South Texas Project  
Units 1 and 2  
Docket Nos. STN 50-498, STN 50-499  
Response to Request for Additional Information Regarding  
Generic Letter 95-07, Dated December 16, 1999

**South Texas Project  
Units 1 and 2  
Generic Letter 95-07  
Response to Request for Additional Information**

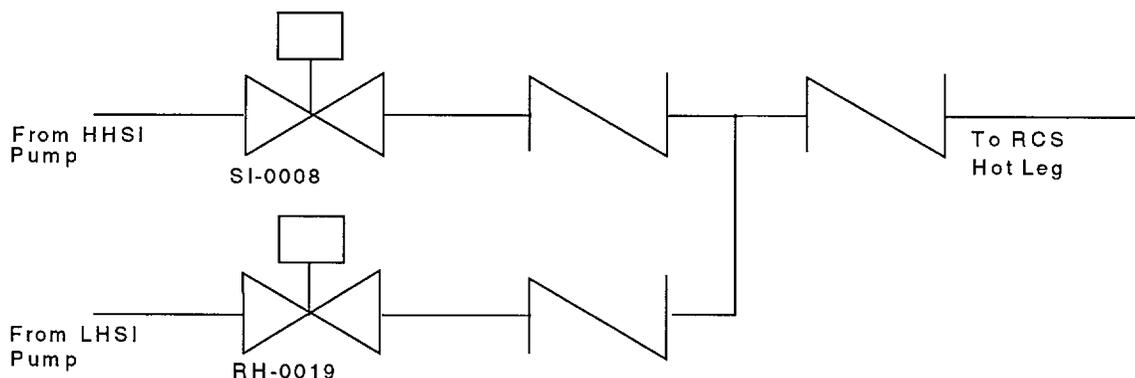
1. Justify use of the 23 psi/°F thermal-induced pressurization rate that was used in pressure locking calculations to determine maximum bonnet pressure for the high head safety injection hot leg isolation valves, 2N121XSI0008A/B/C and 2N122XSI0008A/B/C, the low head safety injection hot leg isolation valves, 1N161XRH0019A/B/C\* and 1N162XRH0019A/B/C\*, and the residual heat removal pump suction isolation valves 1R161XRH0060A/B/C, 1R162XRH0060A/B/C, 1R161XRH0061A/B/C, and 1R162XRH0061A/B/C. Your answer should include the basis for the Westinghouse determination that this is an acceptable thermal induced pressurization rate for use on Westinghouse valves. For example, your explanation should include any test data that was used to validate the 23 psi/°F thermal-induced pressurization rate.

A Westinghouse Owners Group industry survey of pressurization tests was the basis for the 23 psi/°F thermal-induced pressurization rate used in calculations to determine maximum bonnet pressure. The survey results show a wide range of values of thermal pressurization rates. Analysis of the data used the statistical method of geometric mean to reduce the impact of extreme values. The generic pressurization rate of 23 psi/°F was developed using the mean pressurization rate plus three times the standard deviation. These data show that this pressurization rate is valid as long as the temperature rise is no more than 70°F.

The test data from a Westinghouse valve were excluded from computation of the mean discussed above because the pressurization rate was too low; i.e., it would have resulted in undue bias in the non-conservative direction. Therefore, use of 23 psi/°F for Westinghouse valves is considered conservative. Previous discussions with the reviewer indicated that use of 23 psi/°F may be considered non-conservative with respect to general industry practice; however, the South Texas Project considers this value a prudent and conservative treatment for motor-operated valves having low risk significance.
